B6 2nd Floor Struc. Plan
27/5/19

R.C.C. 2ND FLOOR PLAN
TYPE B6

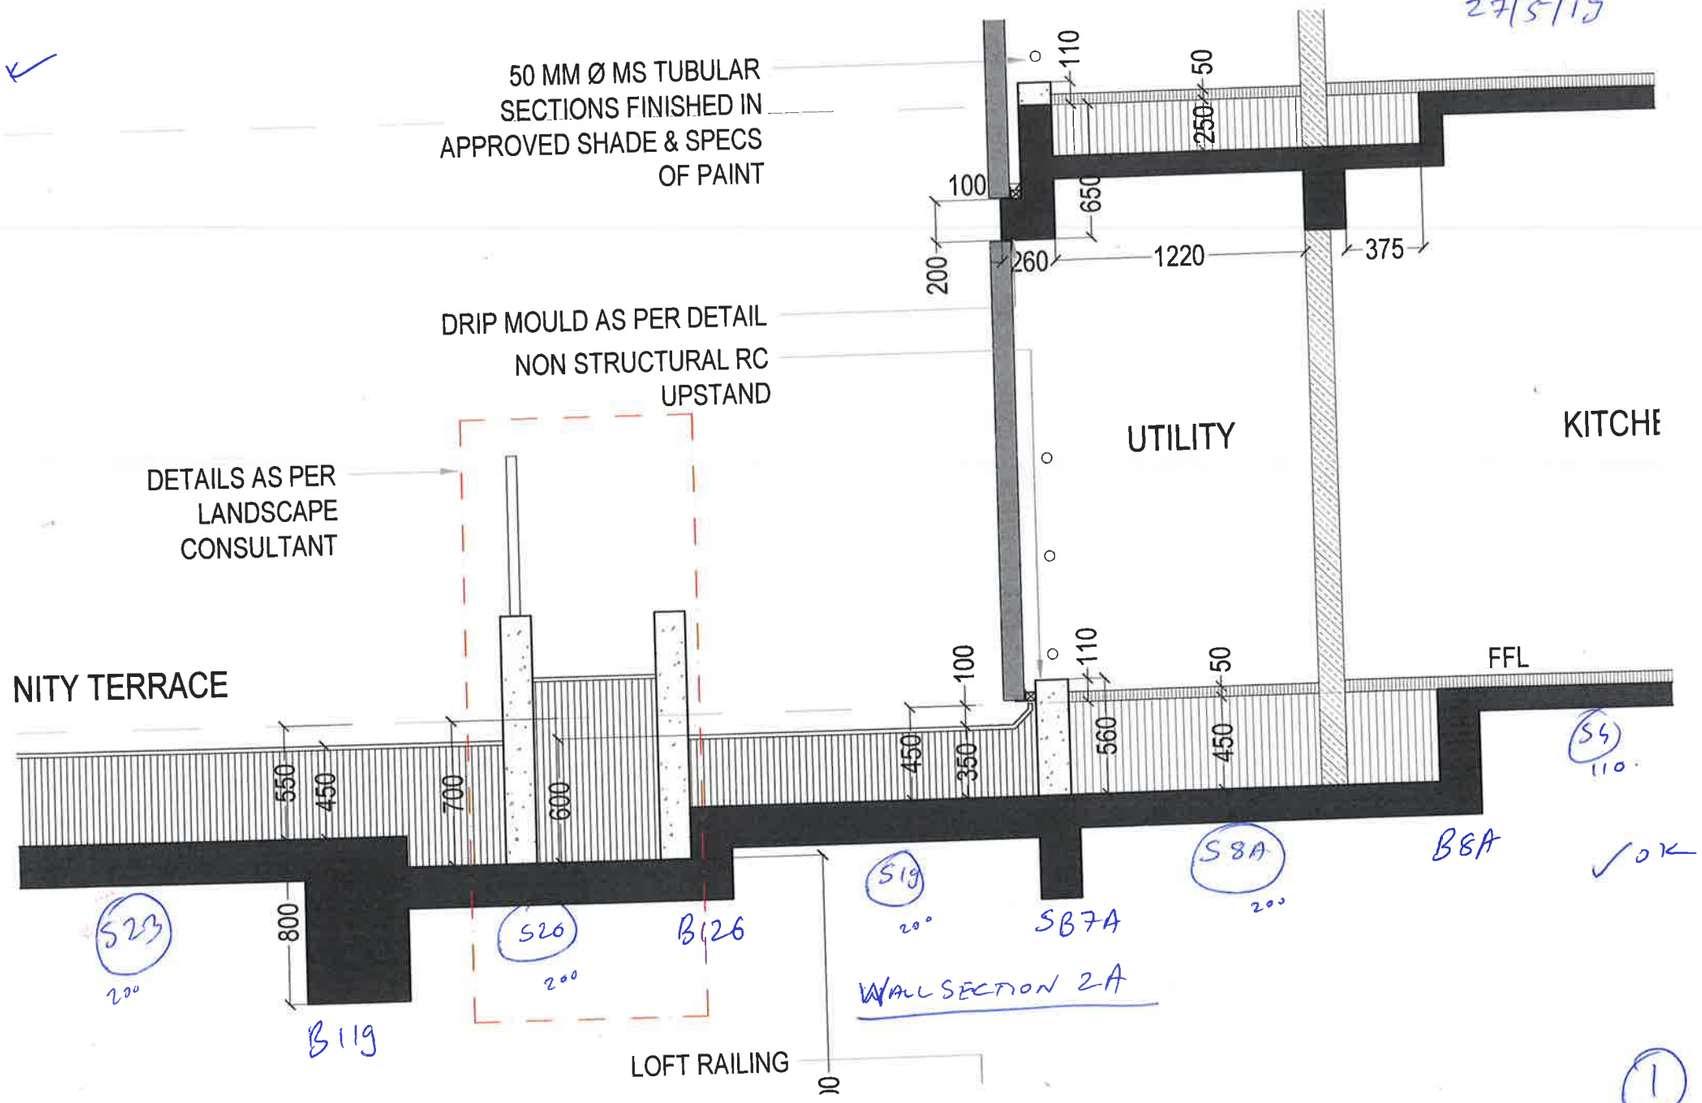
KAPL & SBC
Check Section 14 & Elevation. Portal side thk is 200 & top fascia beam is 400; KAPL to confirm. Also Beam TOP IS 450 sub

Check Section 14

Check cut out profile in Arch dwgs

Check Level of Beam

Check cutout profile

B149 Add to Schedule

BC11 Add to Schedule

B33 has to be inverted.

B35 to be 650mm depth.

Nomenclature missing for beam??

WALL SECTION 13

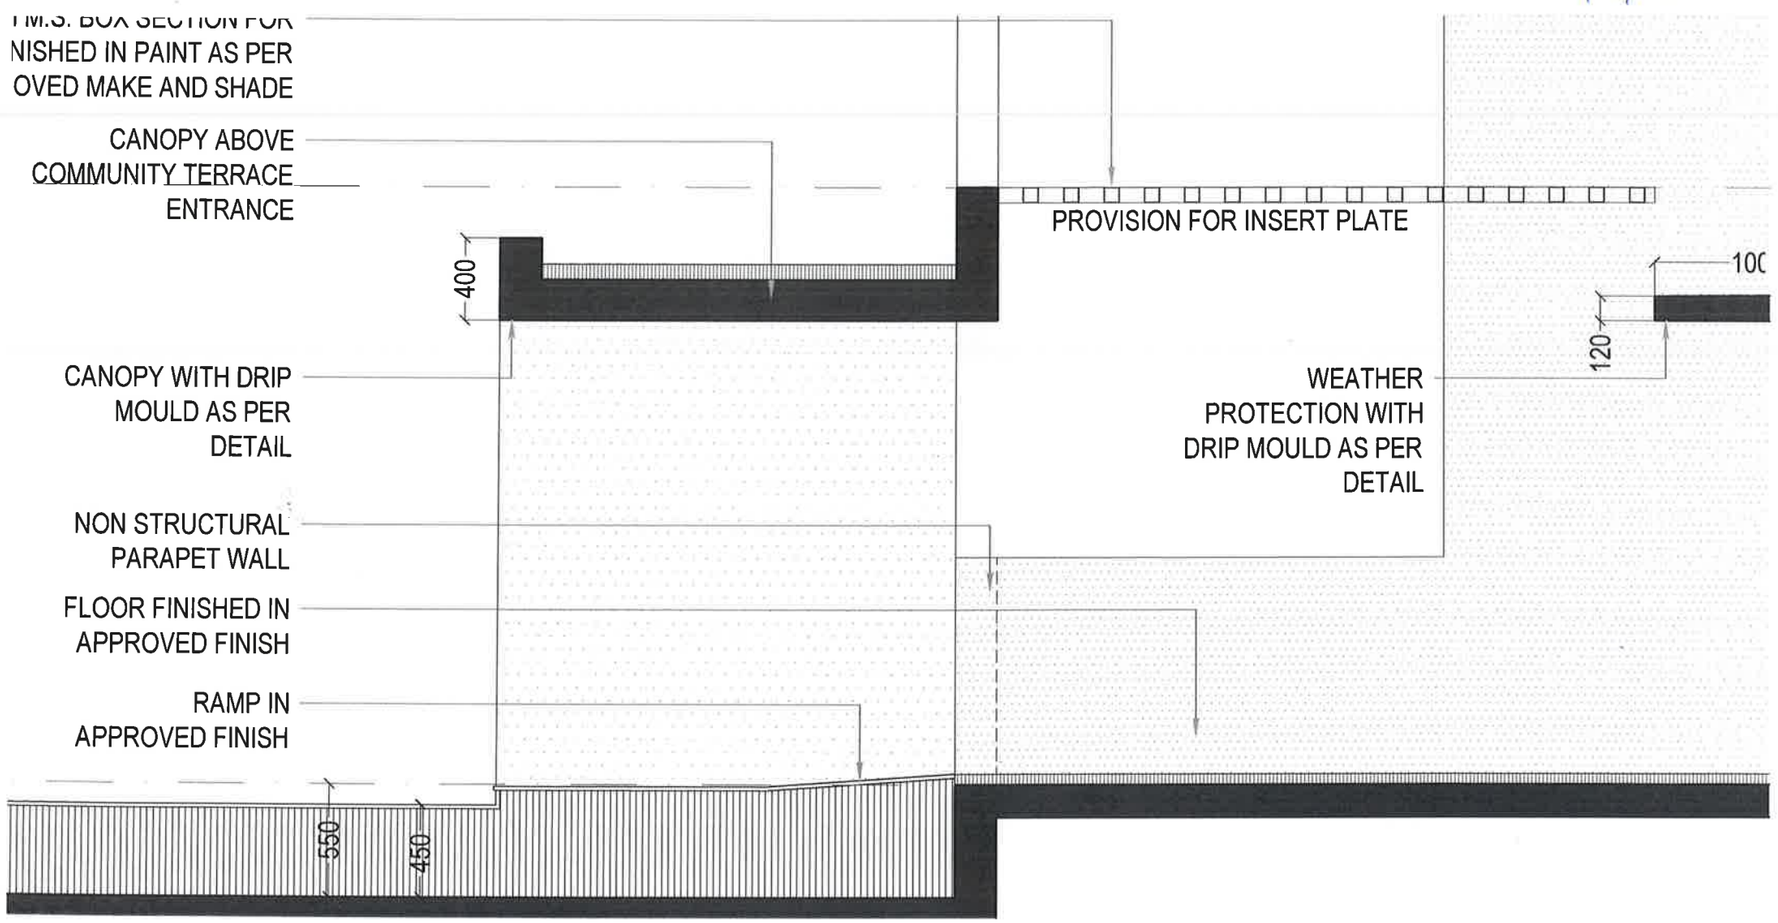
TERRACE ENTRANCE
200
400
KAPL to confirm
DRIP MOULD AS PER DETAIL
2250
100
COMMUNITY TERRACE
550
450
EXTENT OF
STAIRCASE BEYOND
FIRST FLOOR
500
W5B
W5C
1450
800
1450
B13
B6
@ 1st floor
11
10
9
8
7
check for water ingress.
Non. struct wall.
B13 650 Deep.
Non. struct wall.
KAPL To check
B6
2nd floor
27/5/19
WALL SECTION 14
3

KAPL & SBC to check

SBC To Check Beam Top Sunk in plan & change hatch accordingly.

COLUMN ST1 TO TERMINATE BELOW STRIP SUNK LEVEL AT COMMUNITY TERRACE.
